CITY OF SPRING PARK  
PLANNING COMMISSION AGENDA  
JULY 8, 2020 – 6:00 PM  
SPRING PARK CITY HALL

**PLANNING REPORT**

TO: Dan Tolsma  
FROM: Alan Brixius / Daniel Elder  
DATE: July 1, 2020  
RE: Spring Park – Variance request – Side yard setback 4317 Channel Road  
FILE NO: 175.01 – 20.02  
PID: 1911723120033

TO: Dan Tolsma  
FROM: Alan Brixius / Daniel Elder  
DATE: July 1, 2020  
RE: Spring Park – Variance request – Street Side Setback 4364 & 4368 West Arm Road  
FILE NO: 175.01 – 20.03  
PID: 181-172-343-0057 & 181-172-343-0058

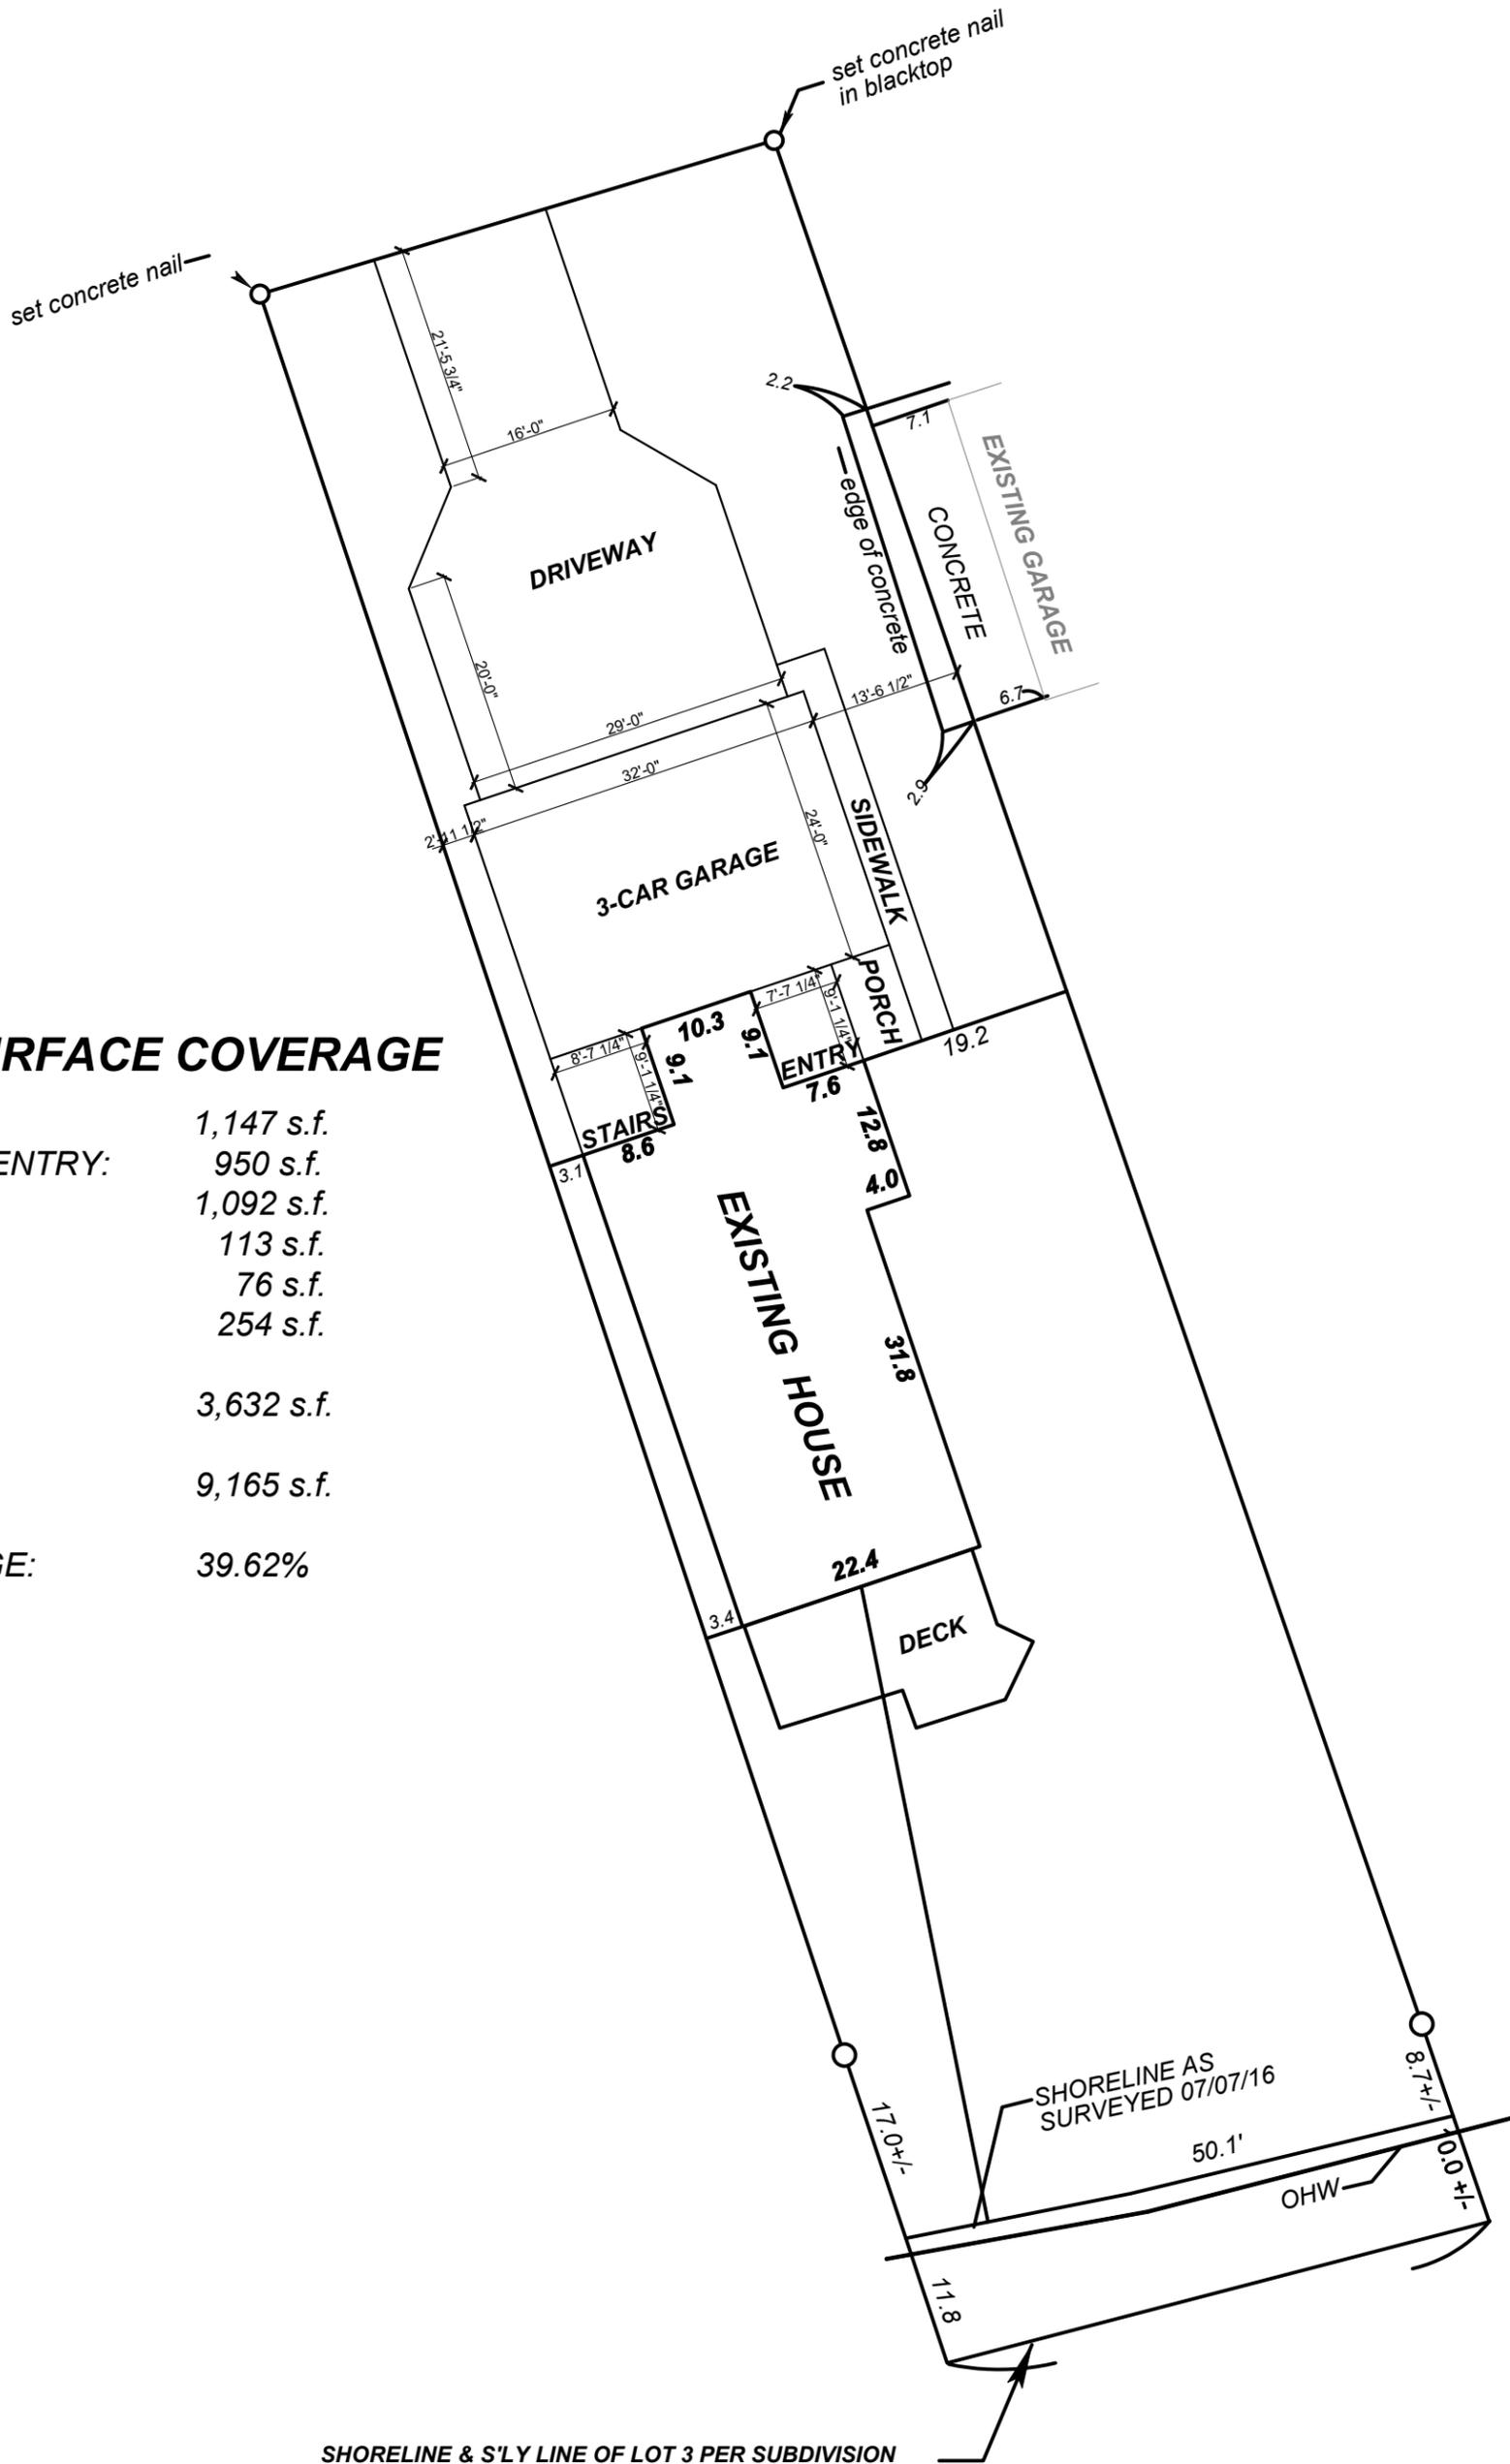
The existing home has a non-conforming setback on the western side yard of 3 feet but is complaint on the all the other setbacks. The current garage has a zero setback from the west lot line and is setback 10.6 ft from Channel Road as shown in Exhibit C.

The table above shows the required amount of setback that a structure must meet in R-1 districts, compared to the proposed setbacks that will be left after the construction of the addition. The new addition requires variances from the required side setback on west lot line.

*Staff Comment: The Spring Park 2040 Comprehensive Plan states in Strategy 2 that it will promote the renovation and reinvestment in existing homes is a priority for the city. The teardown of the garage and expansion of the home will allow for the renovation and reinvestment in the community. In addition, the proposed plan will bring the property into compliance with the street side setback going from 10.6 ft to 41 ft.*

Based on the variance findings of this report staff recommends approval of the applicants request for a variance from the side setback requirements for the property at 4317 Channel Road with the following conditions.

1. Construction will not deviate from the site plan submitted to the city on 6/2/2020 as part of the variance application. Any change to the dimensions of the addition would be subject to a separate review.

**IMPERVIOUS SURFACE COVERAGE**

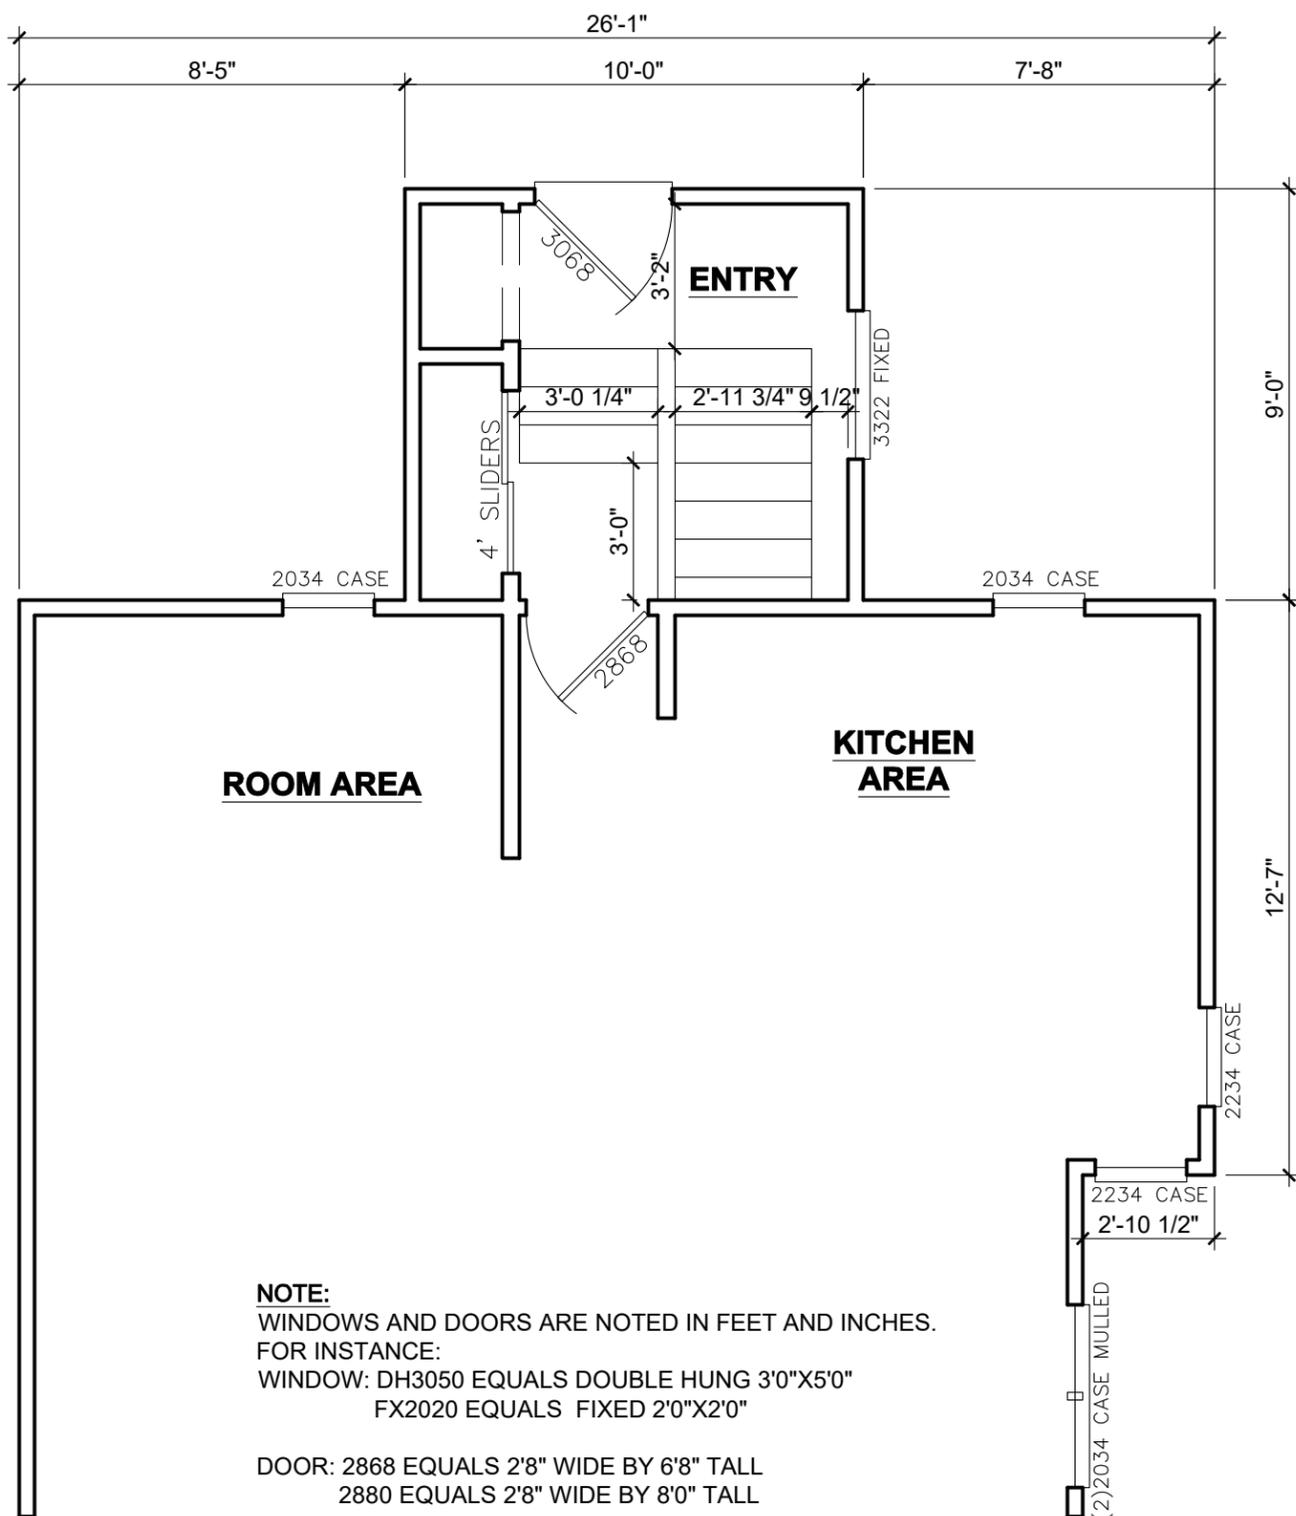
The building addition expands hardcover on the applicant's property to 39.62% impervious surface. However, in Sec. 42-279 of the City Code, Lot Requirements and Setbacks, conditions are outlined in which new construction can be allowed to have up to a 40% impervious surface by meeting the following conditions.

*Comment: The applicant will need to provide a Stormwater Management Plan in order to meet the City's code for construction that exceeds 30% impervious surface. The current proposal has 39.62% impervious surface. The applicant has noted they will be adding a storm management rain garden or swale.*

*The building plans will also need to address gutter and drainage from the site. Staff is concerned that roof drainage may impact the property to the west. As a condition of variance approval the property owner shall install gutters and downspouts that will collect roof drainage and divert it away from the property to the west. The stormwater management plan shall show drainage patterns and location and design of the rain garden and or swale per approval of City Engineer.*

2. The applicant will have to demonstrate building plans that meet the building inspectors and state requirements for buildings within five feet of a lot line. These requirements are outlined in Exhibit E.
3. Given that the amount of impervious surface at the site will exceed 30%, the applicant will need to meet the conditions outlined in Sec. 42-279 (4) b. in order to mitigate the stormwater impacts of the addition.
  - ) The applicant will submit a separate site grading and drainage plan to ensure proper stormwater management practices. This plan will be subject to review and approval by the city engineer.
  - ) The applicant shall install a gutters and down spouts to direct runoff away from the adjacent properties and into one of the storm water management options listed in sec. 42-279.
4. Additional recommendations by City staff

*Proposed Addition  
Site Plan -*

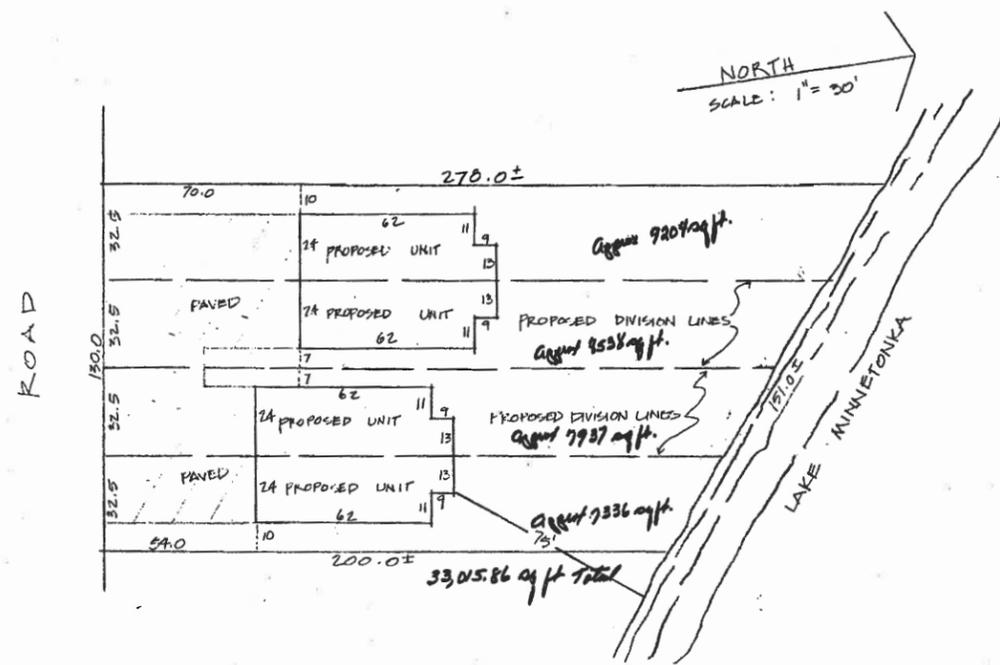
The new garage is not be complaint due to the 15' easement on the property and would be located 20' from the easement. It would however be 35' from West Arm Road paved street surface.

*Staff Comment: The subject lot is subject to a 15' street easement as shown in Exhibit F that is exclusive to the twinhome lots and is not on other properties along West Arm Road. The building addition will maintain a 20 foot setback from the easement and a 35 foot setback from the paved road surface which is similar or greater to other properties along West Arm Road.*

*Staff Comment: As a condition of the variance request the applicant will need to provide a Stormwater Management Plan in order to meet the City's code for construction that exceeds 30% impervious surface. The current proposal has an estimated 31.8% impervious surface. The storm water management plan must identify the proposed drainage patterns and storm water treatment features per the city code. Said plan shall be subject to City Engineer review and approval.*

1. Construction will not deviate from the site plan submitted to the city on 6/9/2020 as part of the variance application. Any change to the dimensions of the addition would be subject to a separate review. All new exterior finishes shall match in color and material type to the existing home.
2. Given that the amount of impervious surface at the site will exceed 30%, the applicant will need to meet the conditions outlined in Sec. 42-279 b. in order to mitigate the stormwater impacts of the addition. If the applicant can show that the impervious surface is less than 30% they can forgo this stipulation. The applicant will submit a separate site grading and drainage plan to ensure proper stormwater management practices. This plan will be subject to review and approval by the city engineer.
